## Response to Agency Comments on the Patrick Bayou Preliminary Site Characterization Report

Comment	Response
<b>TCEQ Enclosure No. 1 Comments on Preliminary Site Characterization Report (PSCR), Patrick Bayou Superfund Site – Deer Park</b>	
1. 1.1 Overview - The second paragraph explains that the southern portion of the bayou is tidally influenced. Figure 1-2 should be revised to clearly illustrate how much of the southern portion of the bayou is tidally influenced.	The extent of tidal influence is not quantified at this time. This will be part of the hydrology evaluation scheduled to begin in the fall of 2006.

16. 8.5 Feasibility Analysis - TCEQ recommends the final remediation program include future performance monitoring activities such as sediment depositional studies and analytical testing of near surface sediments, and/or the media to ensure the intended measure(s) are effective in preventing site re-contamination.	Agreed – The details of the monitoring program will be determined in the Record of Decision (ROD).
<b>TCEQ Enclosure No. 2 Comments Prepared by TCEQ Technical Support dated June 9 2006</b>

TCEQ Enclosure No. 3 Comments Prepared by TCEQ Technical Support dated Ju

Elevations are given in National Geodetic Vertical Datum (NGVD).  
LiDAR-derived data obtained from Tropical Storm Allison Recovery Project (TSARP).  
Stations are placed in 500-foot intervals.

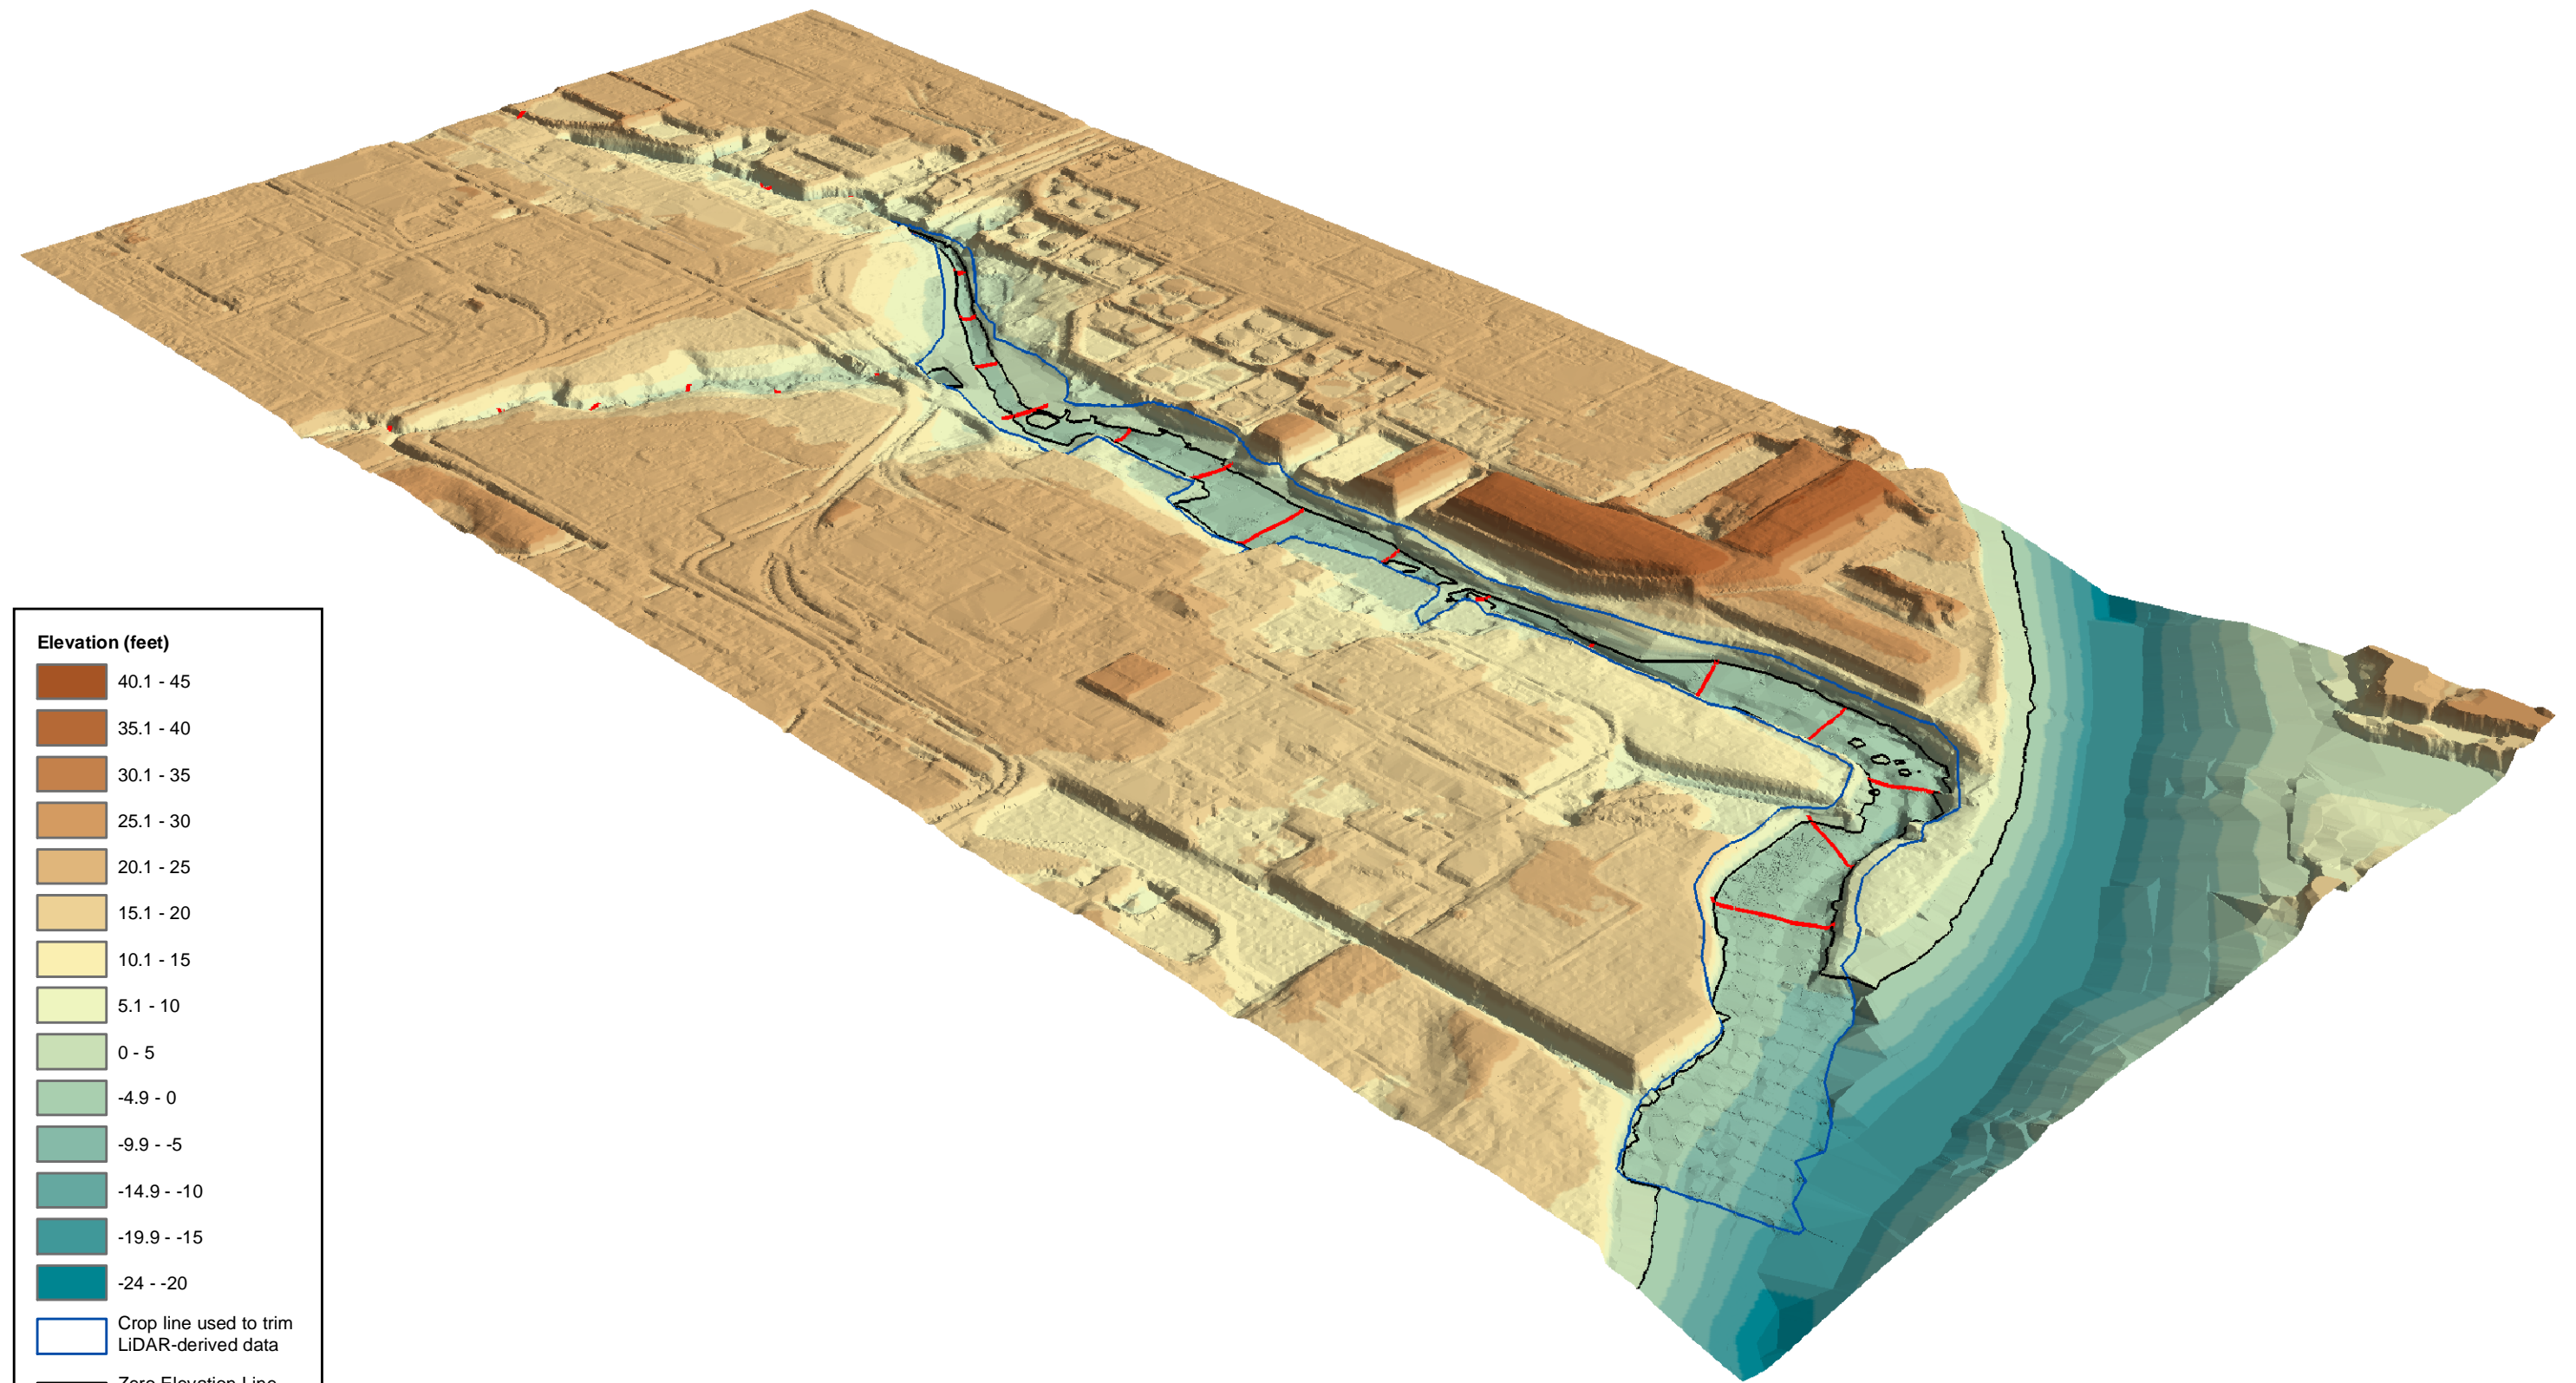
A.3 The trace of the line whose data are represented in Figure 2-5 should be shown on a map. The relevant depths and thicknesses vary <i>laterally</i> in Patrick Bayou (pools and runnels) and it is not clear what data Figure 2-5 represents.	The data in Figure 2-5 provide an overview of the bathymetry for the site. More detailed data are provided in Appendix A of the PSCR.
A.4 Sediment thicknesses are likely to become important. Figure 2-6 represents sediment isopach thicknesses with 2-foot contours. A smaller contour interval and larger map is recommended.	Additional incrementalization of data will be utilized as required in the RI/FS.
<b>Sec B Section 2.6 – Geology:</b>	
B.1 It is recommended that the final report incorporate all available hydrogeologic data (see Appendix B) relevant to contamination and transport to Patrick Bayou. Numerous cross-sections that tie together the available data from primary sources on either side of the bayou are considered essential.	Groundwater discharge to the Bayou will be evaluated as described in response to Comment 6. Their analyses and conclusions will be evaluated as the RI moves forward.

**Figure 3-6**  
 Distribution of 2,3,7,8-TCDD in Patrick Bayou (2000-2003)  
 Preliminary Site Characterization Report

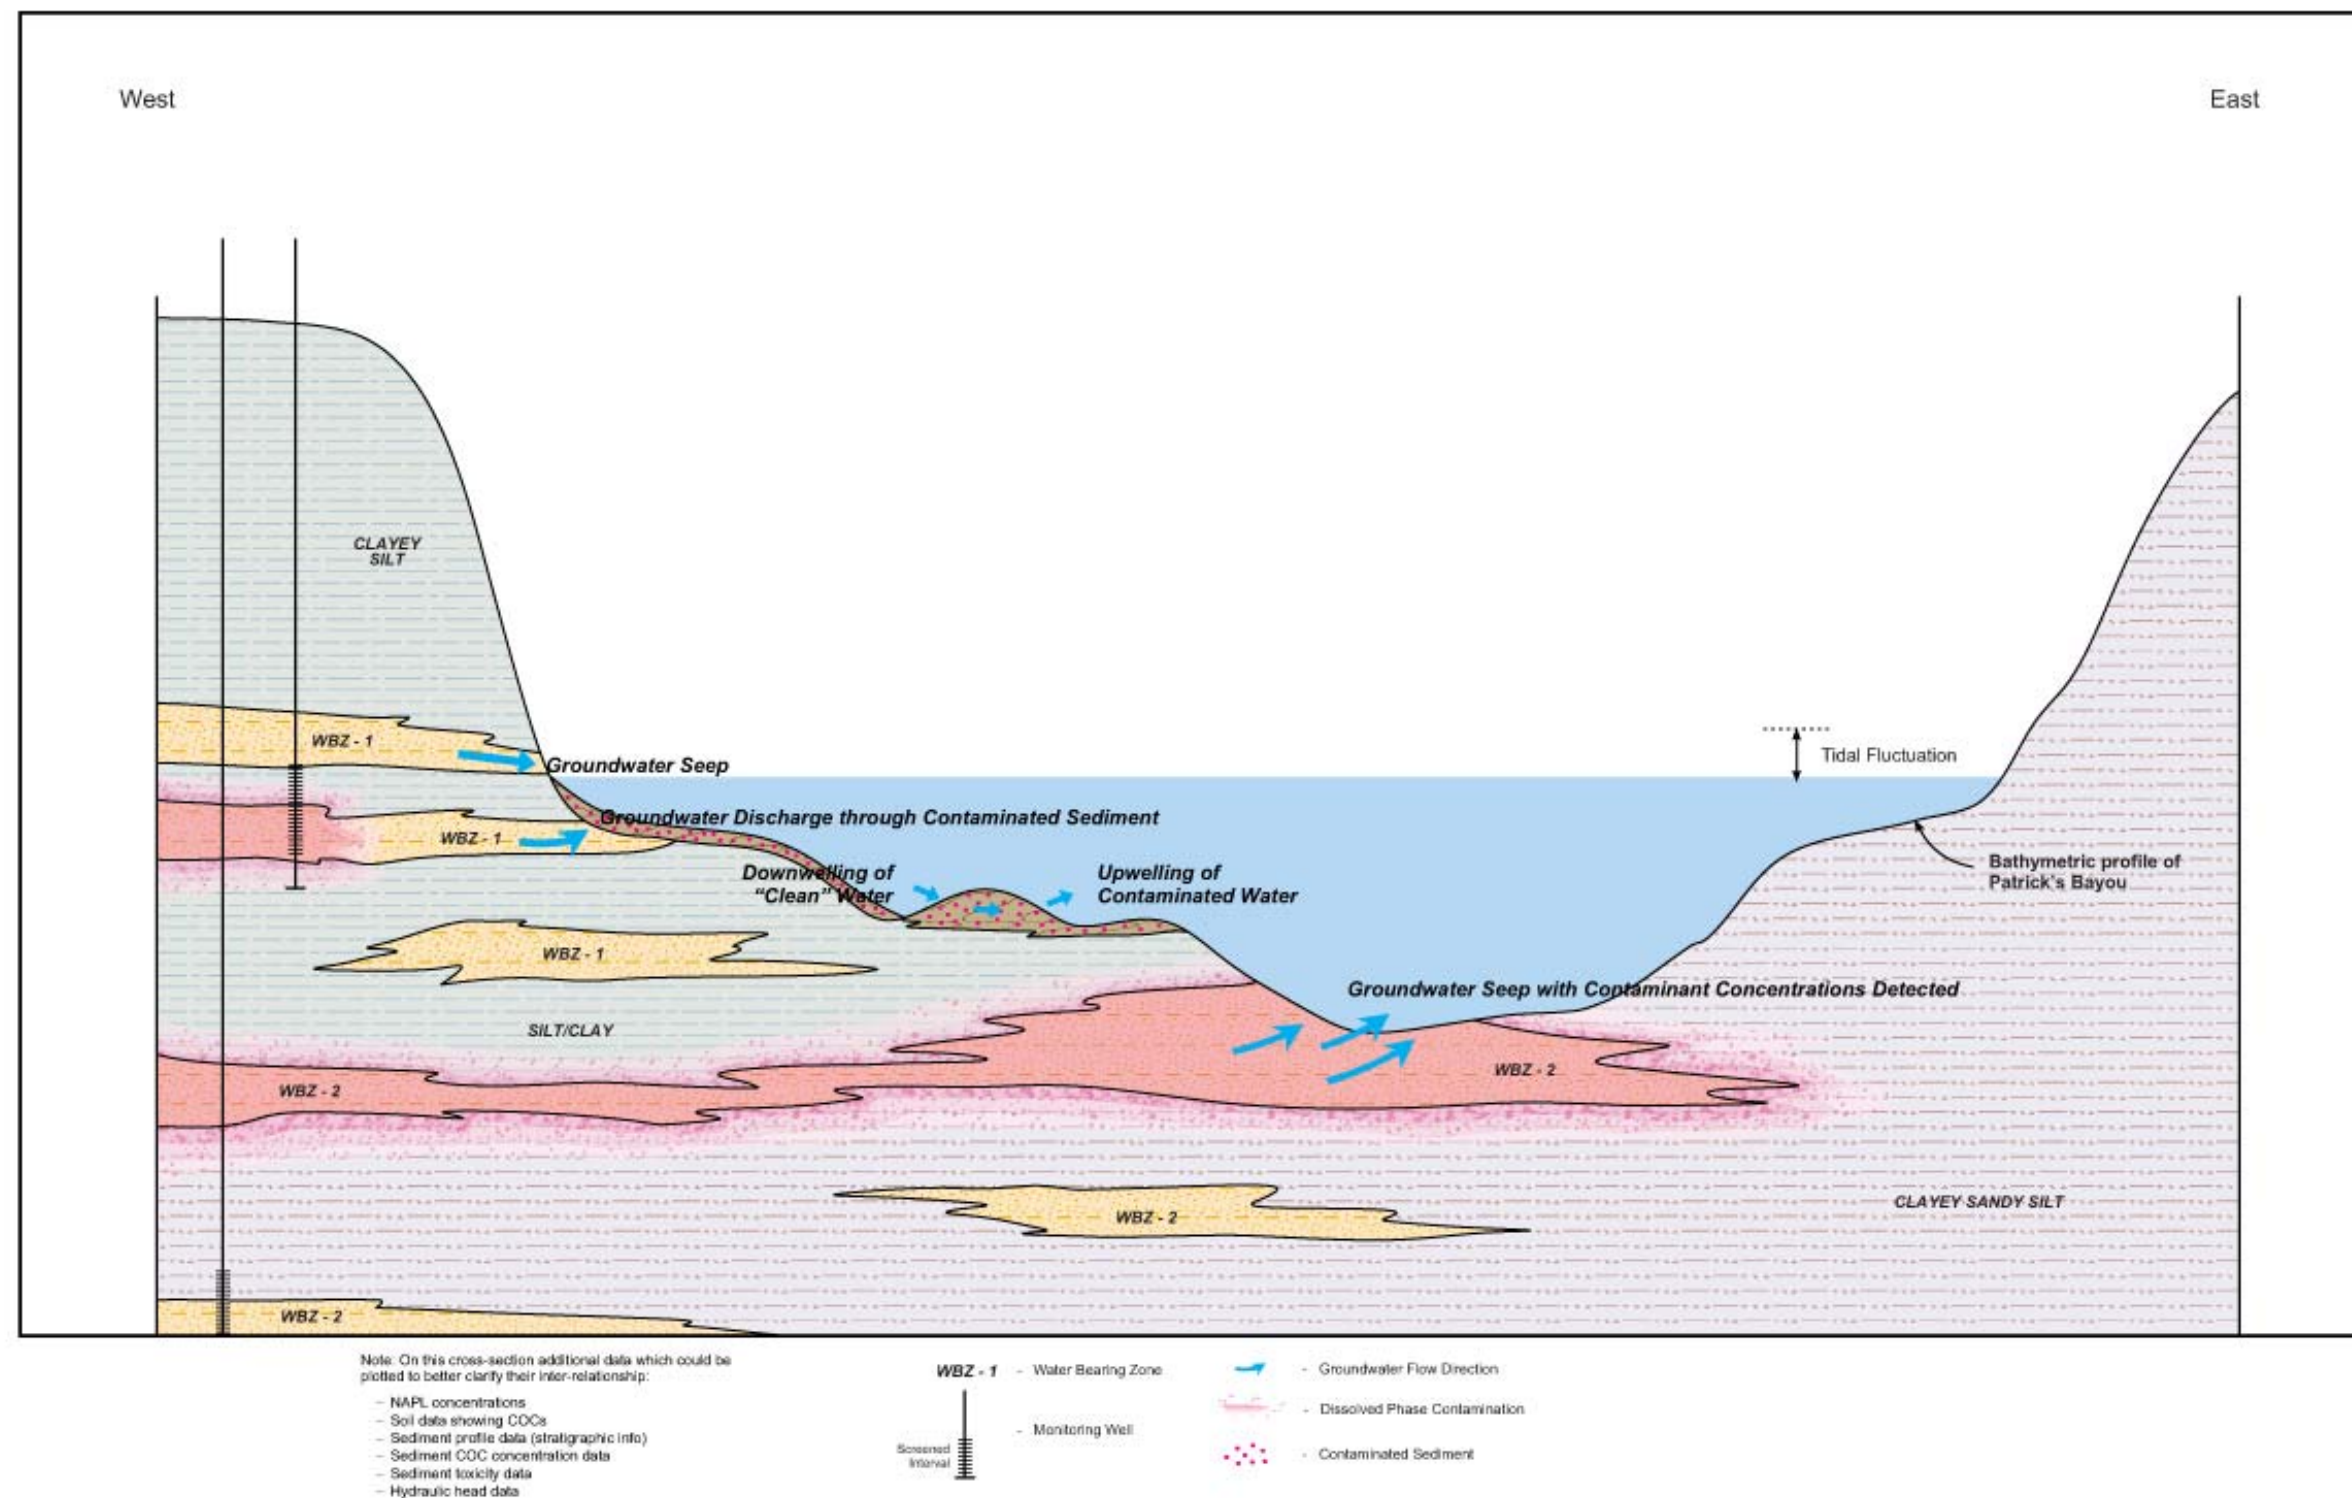
Figure 3-6 should show sediment thickness as Figures 3-2 – 3-9 do.	Agreed. Please refer to the revised Figure 3-6 attached.
“Parsons” should be identified as Parsons Engineering Science (Parsons ES) at least in the references section.	Agreed. All future RI/FS work products will identify Parsons as noted.
Figure 5-2: How are cooling water intakes a source? Are they leaching metals. What are they discharging (according to pathway)? How are “Air Particulates different from “Dust”? This figure should include: 1) in-situ contaminated water (not runoff) as a secondary source, 2) the primary source and pathway leading to the secondary source “in-situ contaminated sediment” [suggest “Direct Discharge could link to contaminated bayou water and in-situ contaminated sediment], 3) sources, pathways and media resulting from contaminant volatilization to	<p>Cooling water intakes from the Houston Ship Channel (HSC) draw in potential contaminants that are discharged into Patrick Bayou through the OxyVinyl outfalls. Regional air particulates are considered different from locally derived dust and may be an important consideration as an ambient source of contaminants such as mercury and dioxins.</p> <p>Please refer to the revised Figure attached.</p>

\* For aquatic plants, uptake is considered the route of exposure

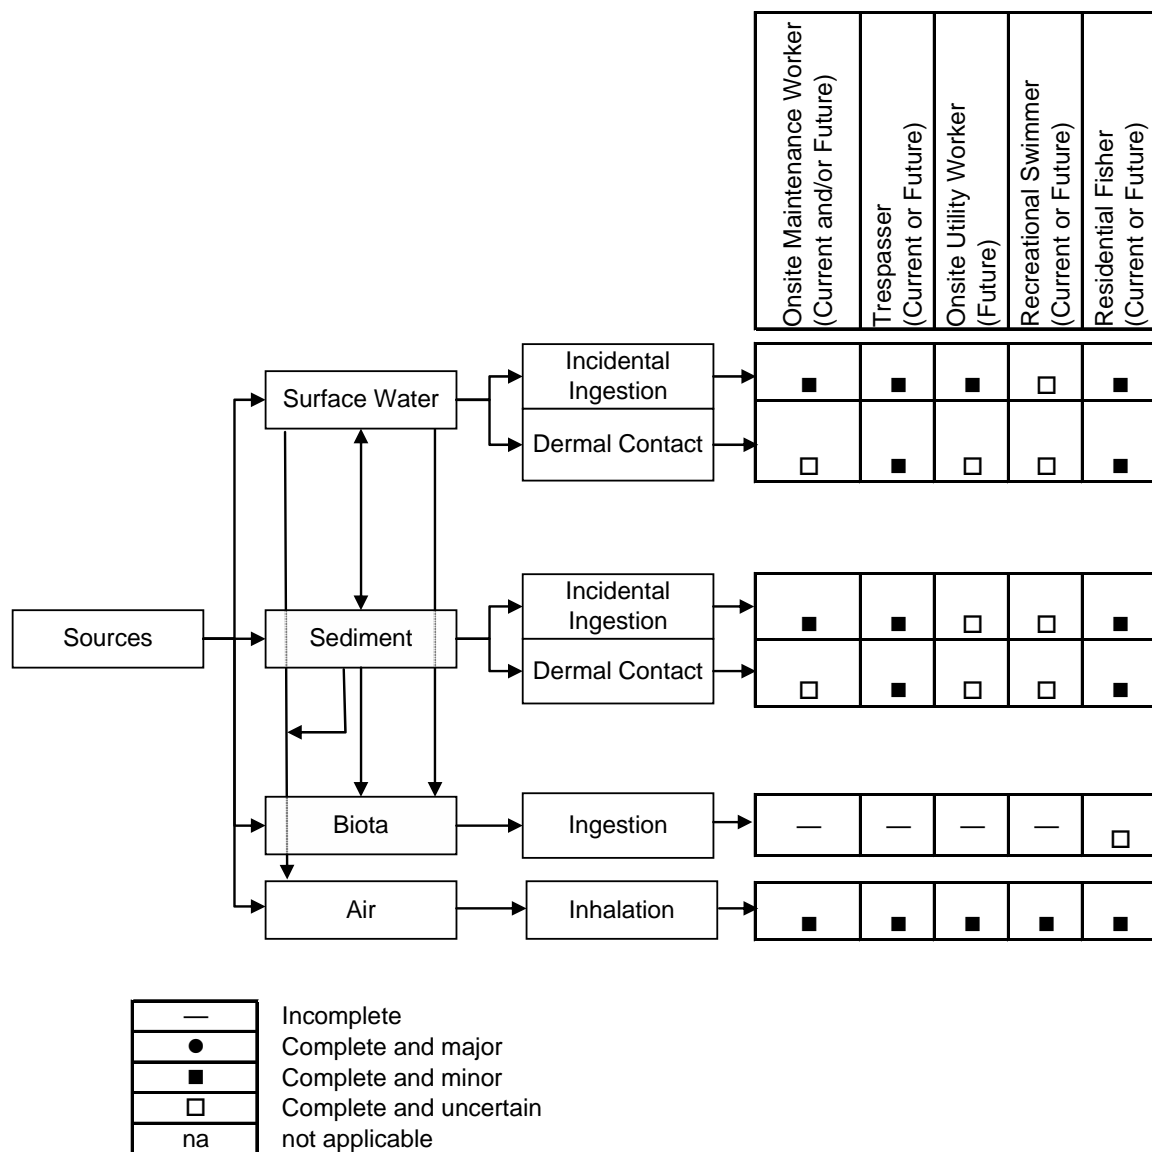
air.	
Figure 5-3: This figure is not clear. Suggest enlarging or recreating.	The figure will be modified to make it more legible in future work products (attached).
Figure 5-5: If uptake by plants can be cross-referenced with “ingestion”, then the ingestion pathways are not “na”. Uptake should be included or cross-referenced with ingestion. Furthermore, the uptake pathway would be “complete and major (•)” between plants and water (especially for metals).	Agreed. Please refer to the revised Figure 5-5 attached. Uptake by plants is considered a complete and major pathway and will be evaluated in the risk assessment to the extent possible; however, there are limited toxicity information related to aquatic plants.
Figure 5-6: Contaminant volatilization from groundwater, soils and sediments and subsequent inhalation of vapors should also be considered here (see comment, Section 5.3). Also see comments, p 80, below.	Agreed. Please refer to the revised Figures 5-5 and 5-6 attached. Inhalation from surface water and sediments are considered complete pathways for the Site. Subsurface volatilization to air from upland soils and upgradient groundwater are being evaluated under the TRRP program. Results of this evaluation will be referenced and included in the RI/FS as appropriate.

77-78, § 5.2.2.4 Birds. Ingestion of water by each group of birds should be included as a potential exposure point even if minor	Agreed – Please refer to revised Figure 5-5. This pathway is considered complete and will be evaluated in subsequent RI/FS

71, § 5 Preliminary Conceptual Site Model. Contaminant volatilization and vapor inhalation should also be considered throughout Section 5.1	The volatilization of contaminants from sediments and surface water will be evaluated. Please refer to the revised Figures 5-5 and 5-6 attached. Results of this evaluation will be referenced and included in the RI/FS as appropriate.
72, § 5.1.2 Release Mechanisms, last sentence. "Other potential... and leaching from impacted surface or subsurface soils impacts."	Agreed – will be modified accordingly in future RI/FS work products.
77, § 5.2.2.2 Benthic Invertebrates. Were any mollusks or barnacles observed along shorelines (their presence might be expected on rip rap)?	During a site/ecological checklist visit, no mollusks or barnacles were observed in those areas that were accessible to the shoreline.
77, § 5.2.2.3 Fish. Pelagic fish can ingest suspended sediment (Figure 5-5 includes this potential pathway)	Agreed – Please refer to revised Figure 5-5. This pathway is considered complete and will be evaluated in subsequent RI/FS work products (risk assessment).

(Figure 5-5 includes this)	work products (risk assessment).
79, § 5.3 Human Health CSM. Contaminant volatilization and vapor inhalation should also be considered throughout this Section.	Volatilization for sediments and surface waters will be considered. Please refer to the revised Figures 5-5 and 5-6 attached. Results of this evaluation will be referenced and included in the RI/FS as appropriate.
80, § 5.3.2 Potential Exposure Pathways. ¶2 of this page (previous section) states that there is “some potential” for use in the area downstream the bridge/pipeline although unlikely due to marine security zones. If ANY potential exists, then the exposure pathways (recreational: swimmer, fisher) are complete and must be assessed. Calculated risk values may be very low, however, they must be considered.	Volatilization for sediments and surface waters will be considered. Please refer to the revised Figures 5-5 and 5-6 attached. Results of this evaluation will be referenced and included in the RI/FS as appropriate.

80, § 5.3.2 Potential Exposure Pathways. Although groundwater has been deemed non-potable, potential for exposure due to volatilization should be considered.	Please refer to the revised Figures 5-5 and 5-6 attached. Inhalation from surface water and sediments are considered complete pathways for the Site. Subsurface volatilization to air from upland soils and upgradient groundwater are being evaluated under the TRRP program. Results of this evaluation will be referenced and included in the RI/FS as appropriate.
90, § 7 Identification of Potential Remedial Technologies, ¶2, 1st sentence. Provide citation for “USEPA Sediment Management Guidance Document”. US EPA, 2005?	Agreed – Will modify accordingly.
99 § 8.3.2 Ecological and Human CSMs, Chemical Data. Sediment, Surface water and Biota are listed. Groundwater and soils should be included due to their potential contribution	Please see revised Figure 5-2, 5-5, and 5-6 for updated exposure pathways. Groundwater and soils are considered potential off-site sources of contaminants to the site (e.g., soil erosion to sediment, groundwater discharge to surface water) but are not exposure media for the Site. Groundwater and soils will be addressed as source media in the RI/FS. Surface water and sediment exposure to receptors will address potential exposure to groundwater discharging to the site and soil runoff/erosion. Risks associated with off-site groundwater and soil
